SECTION 12 SPECIAL PERMIT WITH DESIGN REVIEW
 115 SEQUIN DR
 FOR CONSTRUCTION OF NEW WAREHOUSE BUILDING
 MEETING DATE : DECEMBER 12, 2023

PUBLIC HEARING #1
 12/12/23 AGENDA

Re: Proposed Warehouse Building - 115 Sequin Drive
Section 12 Special Permit

PLANTING PLAN

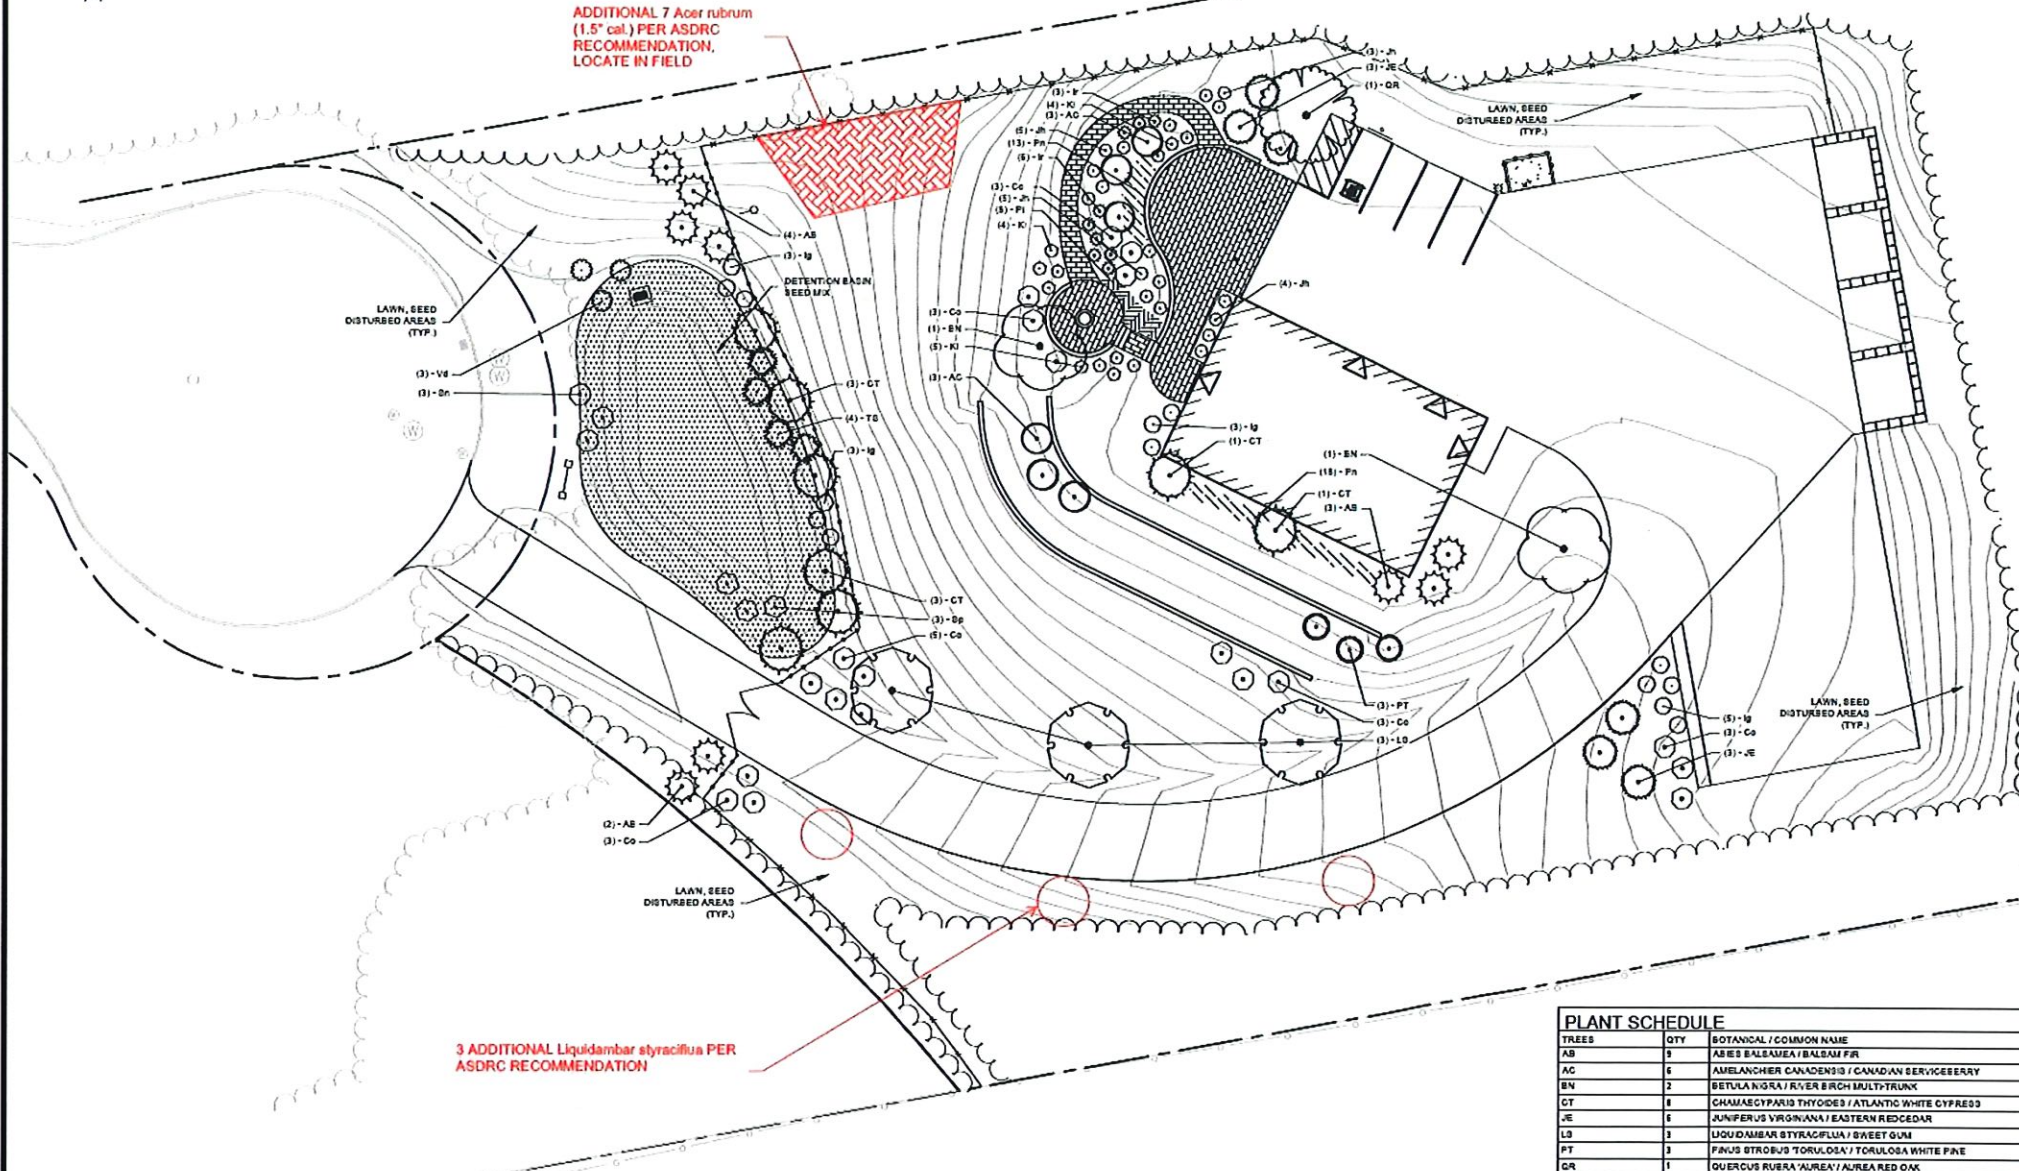
- Add 8-10 trees, of less than 2.5-inch caliper, to re-naturalize the regraded areas;
- The natural dumpster enclosure shall match the color palette of the building;
- A double row of trees, of less than 2.5-inch caliper, shall be installed along the entrance drive.

ADDITIONAL 7 *Acer rubrum*
(1.5" cal.) PER ASDRC
RECOMMENDATION.
LOCATE IN FIELD

3 ADDITIONAL *Liquidambar styraciflua* PER
ASDRC RECOMMENDATION
